# DETAILED CONSERVATION COMMISSION AGENDA

Date: Thursday, January 27, 2022

### 1. (7:00) 152 Suffolk Rd – NOI – backyard pool, sports court, patio, and greenhouse – DEP #239-911

**5. (8:15) Hammond Pond Parkway – NOI – roadway and corridor improvement -- DEP #239-???**

CONTINUED ON  
SHEET NO. 13

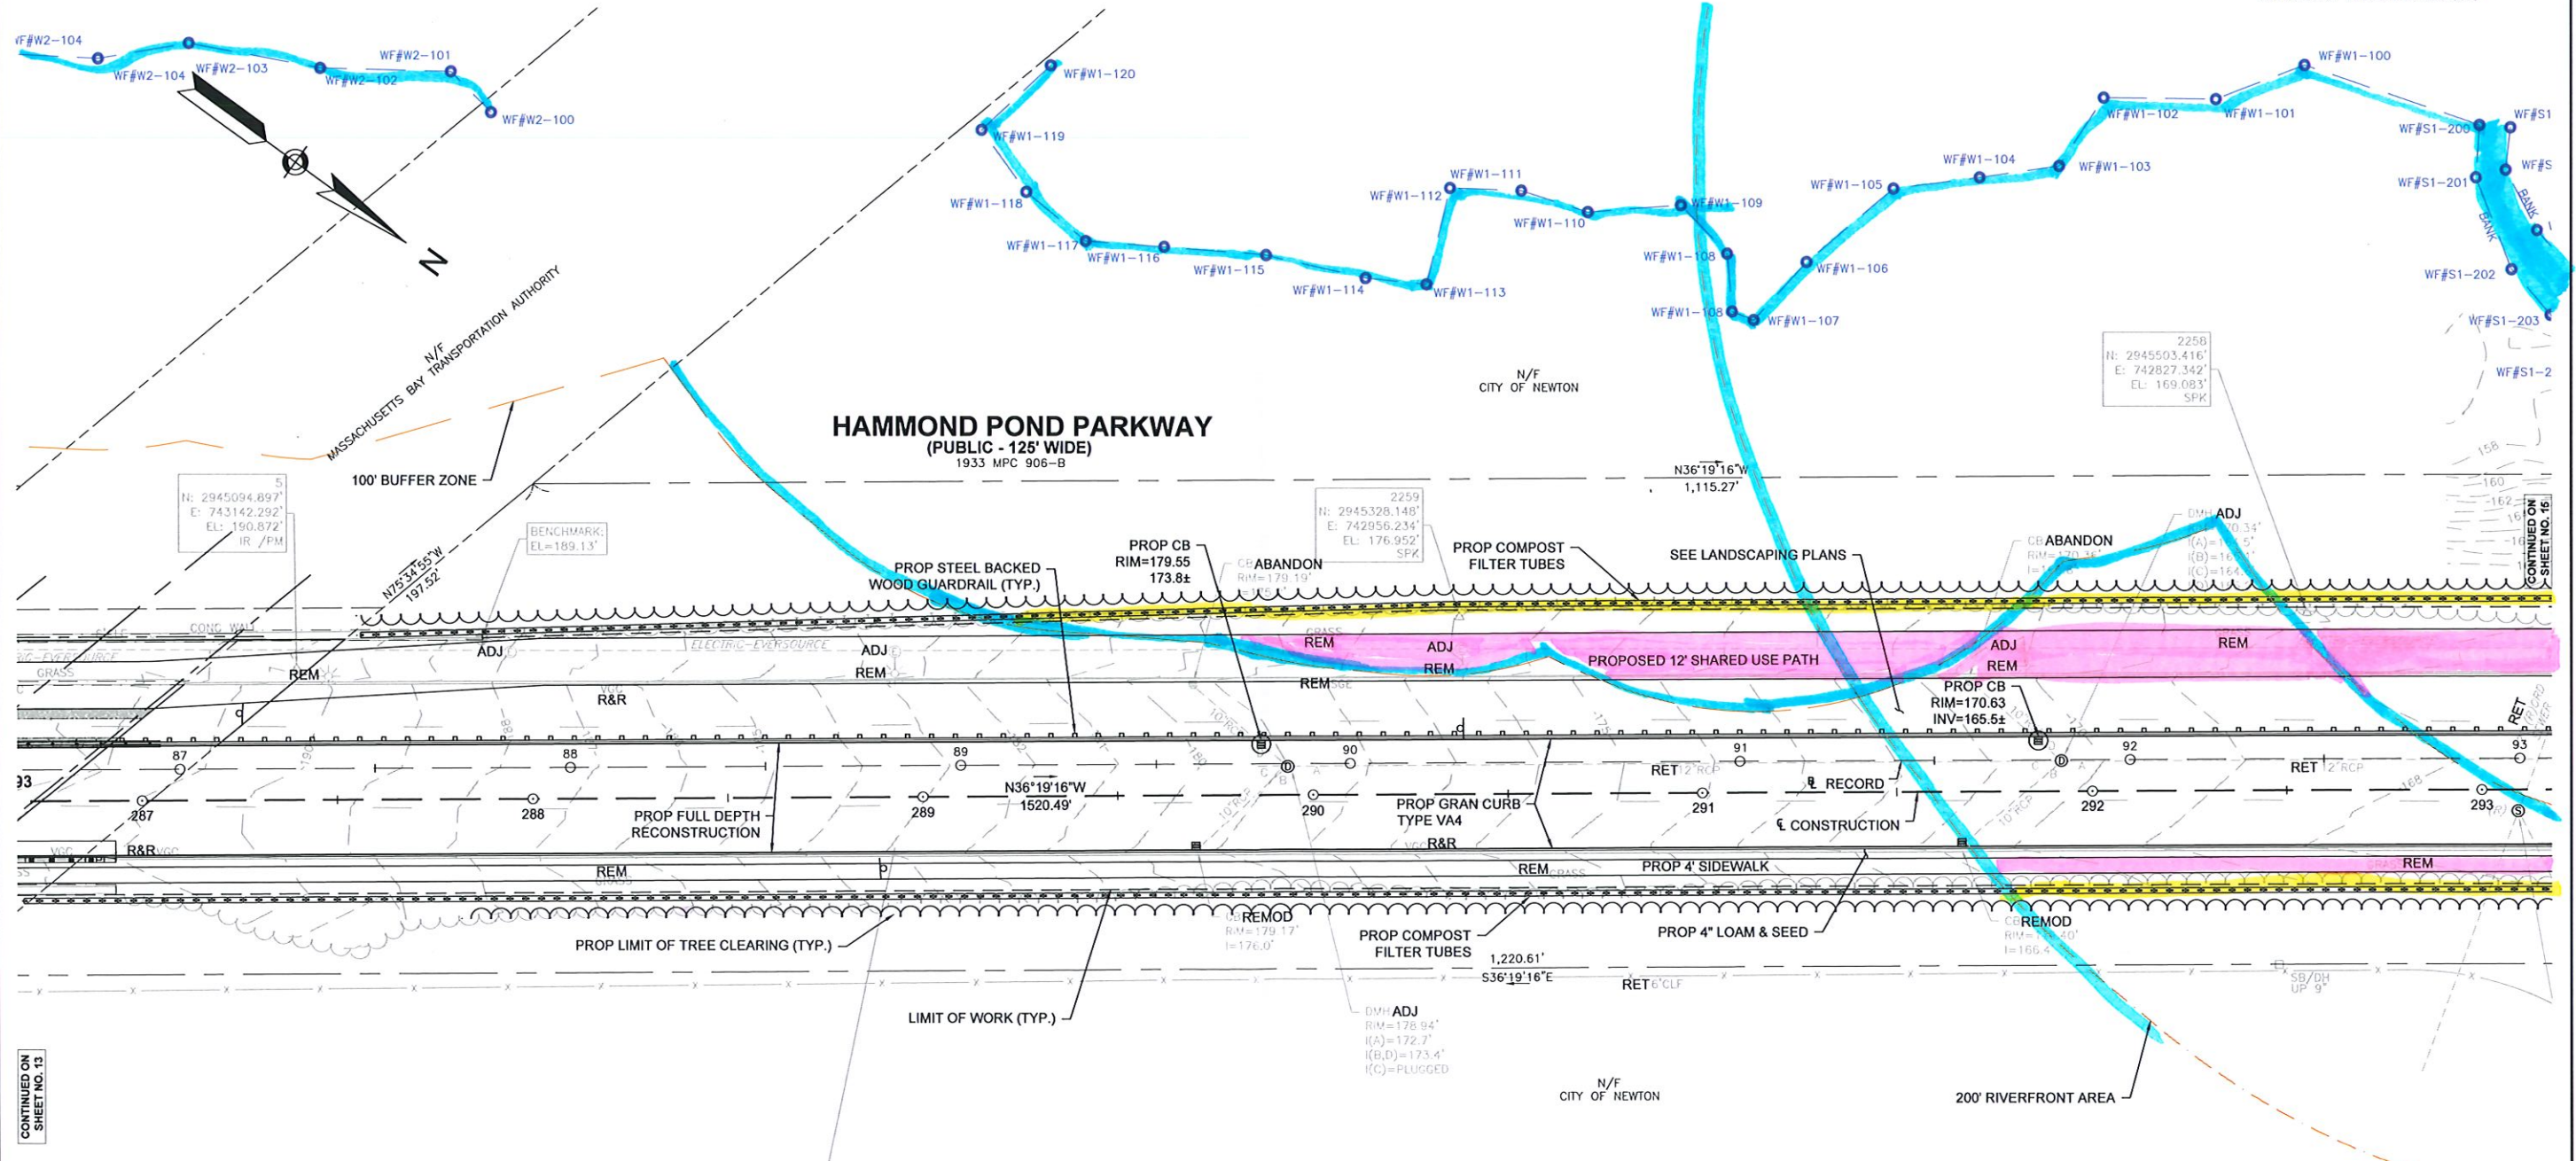
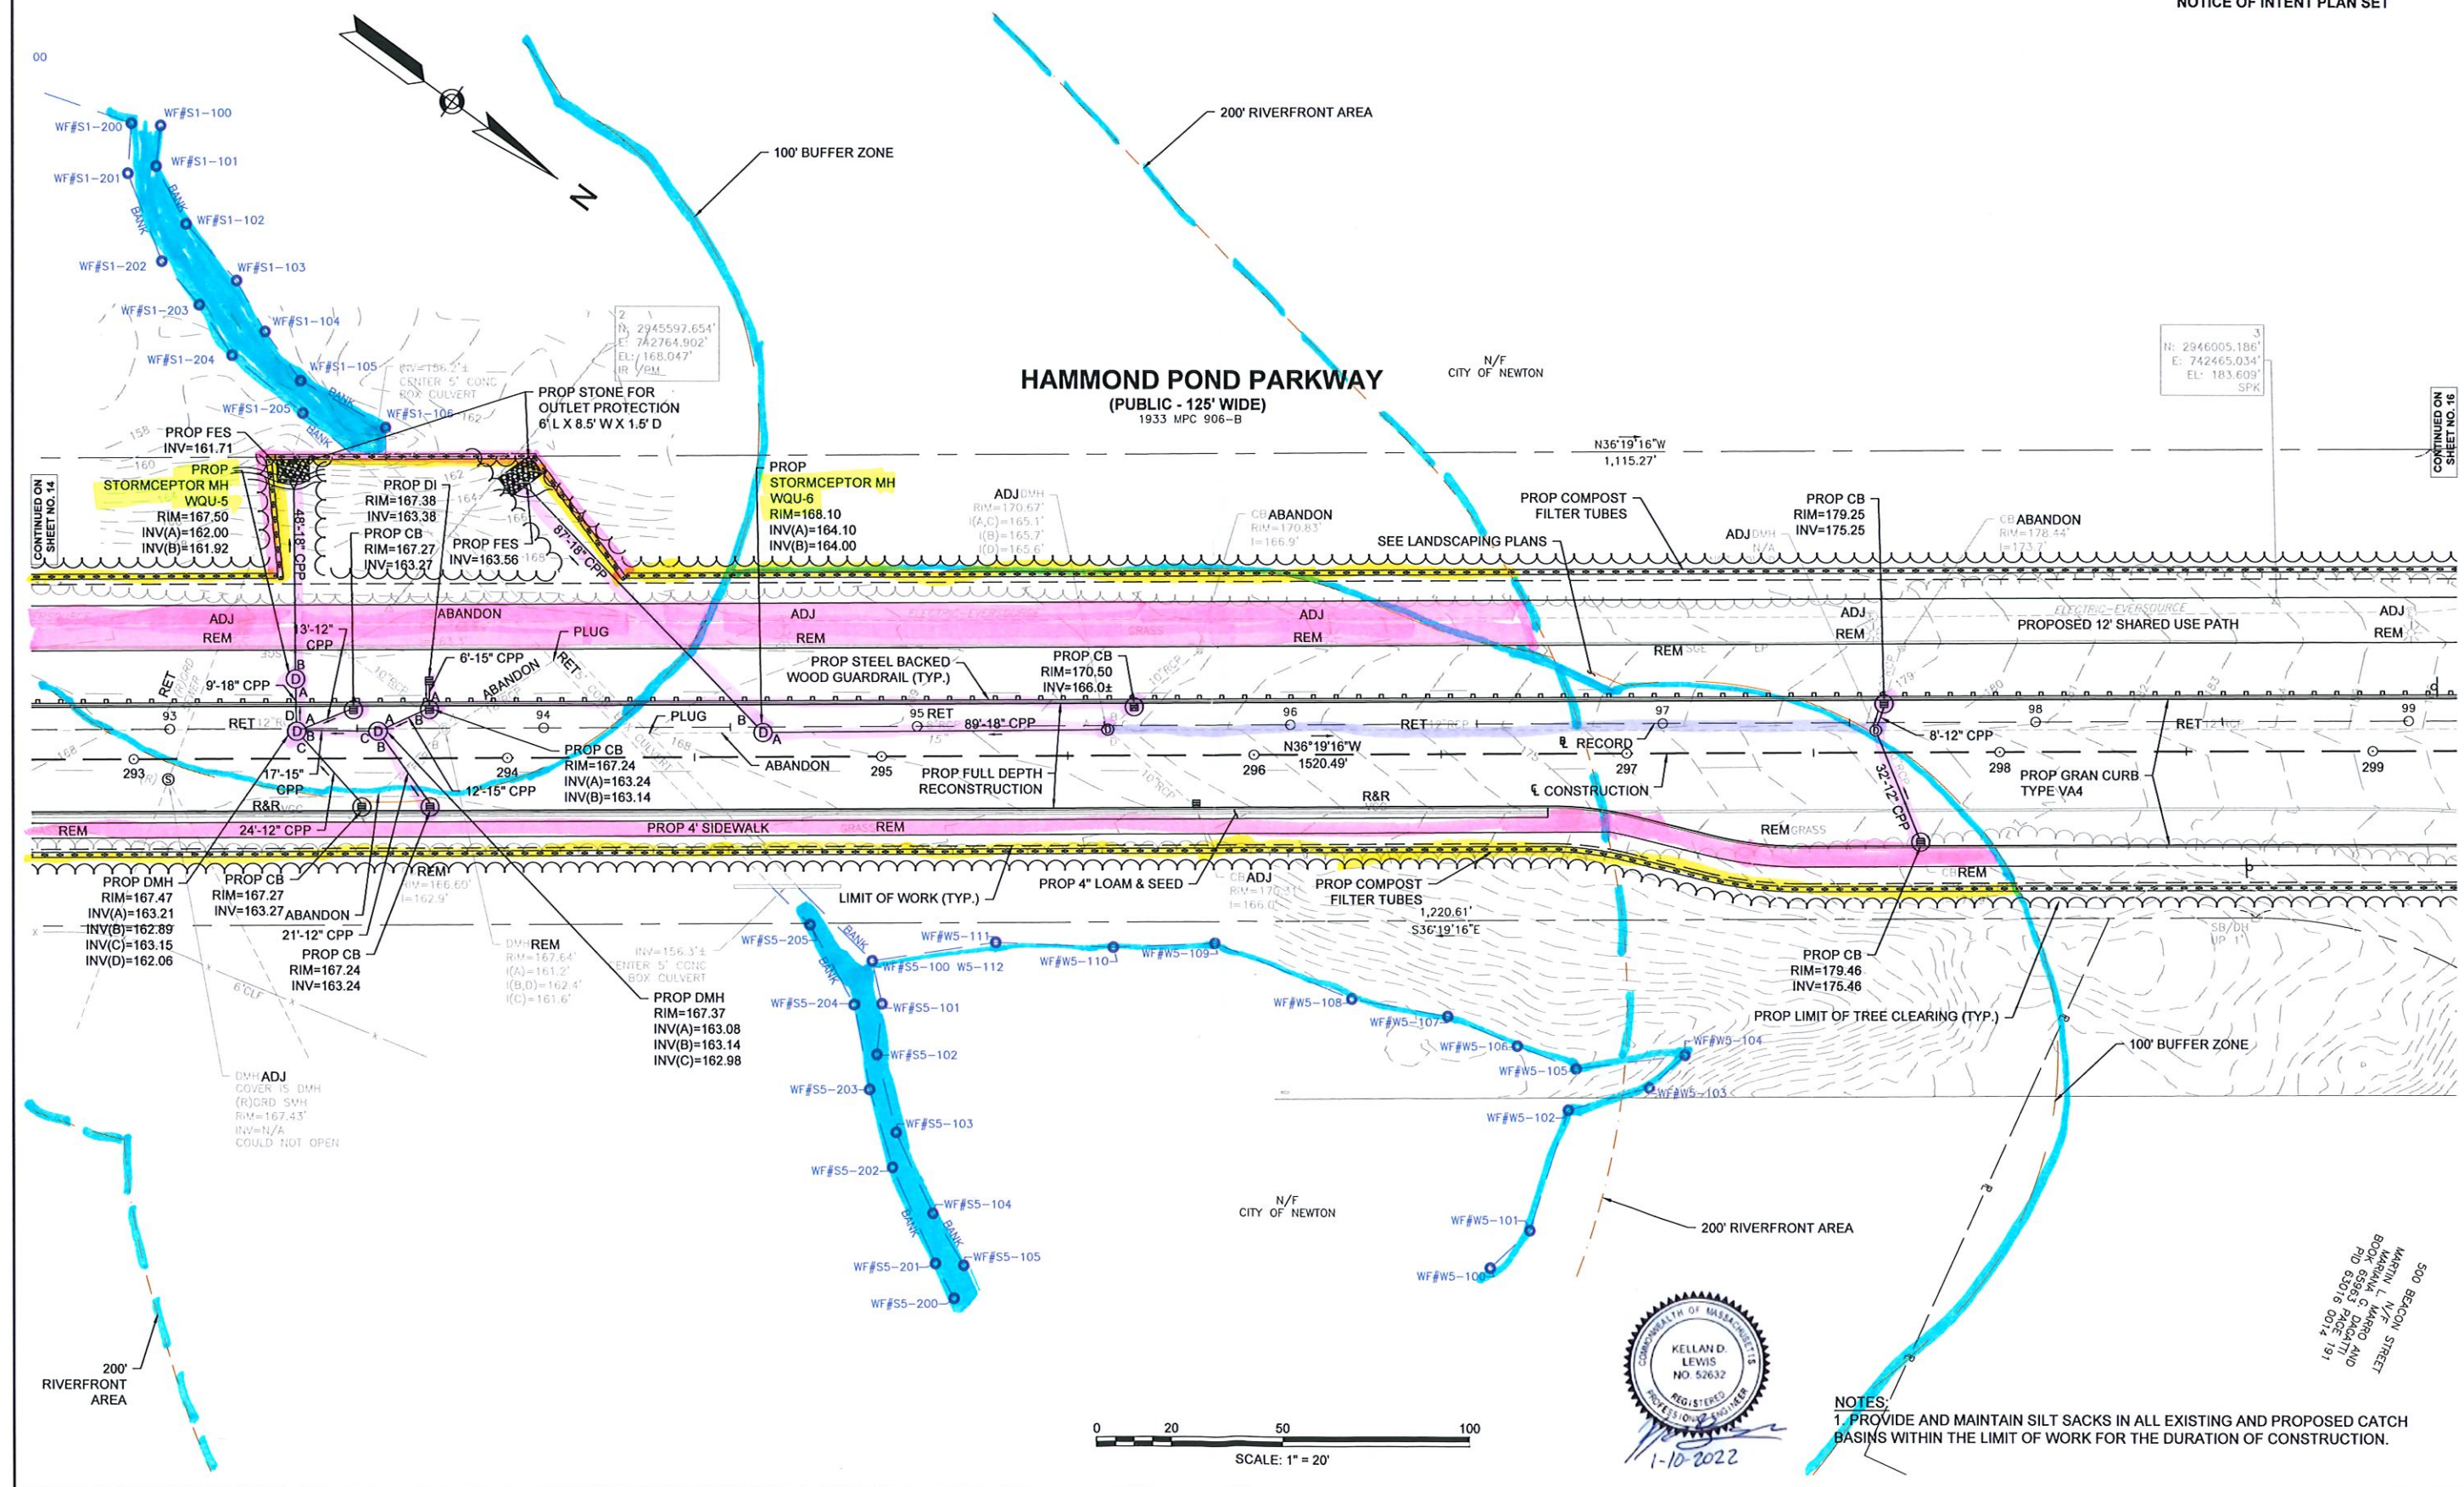
- Staff sought and received revised plans with improved legibility.
- The majority of the alterations within jurisdictional wetland areas are within degraded and disturbed areas (i.e., within the existing roadway and grass/dirt shoulder – “inboard of the existing guardrail”). Overall “paved” area will be reduced.

- The plans provided are very “conceptual” and identified as “not for construction”. More detail may be necessary
- Questions:

- If areas clearing (and grading?) along the edge of the tree line are required to construct the shared use path, those areas should be clearly identified on the plans.

- There will be significant grading at the northeast corner of the new parking area, yet no new grade lines are shown and it appears that insufficient space is provided for side slopes. How will this area be addressed?
- On Landscape Plan sheet 5 there is a “limit of grading” label that appears to be on the property line. It should be removed.
- There is no erosion control/limit of work shown that would protect the “island of trees” near Hammond Brook. That should be added.
- Will there be any invasive control efforts?

- Stockpiling areas should be identified on the plans.

- Compost sock will not provide sufficient erosion controls around the new stormwater discharge points (excavation in steep slopes) and the parking lot construction area (where significant fill is being brought in on an existing steep slope). Erosion control must be entrenched silt fence and staked compost sock.
- Will the road remain open during construction?
- When the old stormwater system is abandoned, will there be any disturbance outside the street layout?
- Will there always be a functioning stormwater collection and distribution system?

- There aren't details of the stormwater discharge points, but the plans indicate riprap aprons 5' L X 7.1' W X 1.5' D. How will the riprap be retained on steep slopes?

- Staff Recommendation: Once all questions are answered and concerns addressed and whenever the Commission feels that the plans are adequate for the Commission's purposes, vote to close the hearing and issue an OOC with the following special conditions:

- Stockpiling shall ...
  - Outfall details must ...
  - An invasives control plan shall ...
